# UNITED STATES PATENT AND TRADEMARK OFFICE

10/599,158

<b>Office Action Summary</b>	<b>Application No.</b> 10/599,158	<b>Applicant(s)</b> KURTH, MATIN	
	<b>Examiner</b> ROBERTA DELISLE	<b>Art Unit</b> 3677

## **DETAILED ACTION**

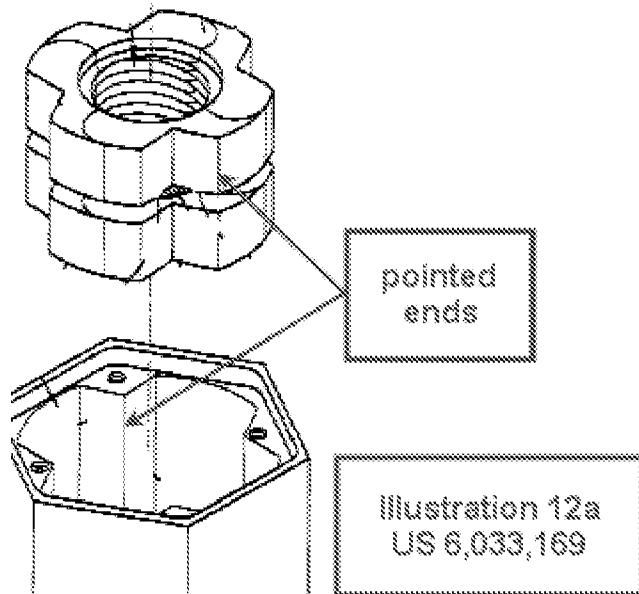
**(New)** The device of Claim 11, wherein said projections (28, 29, 40, 41) each include curved sides (Column 4 Lines 29-31, “cam faces” & “camming surfaces”) terminating in pointed ends (See Illustration 12a below)
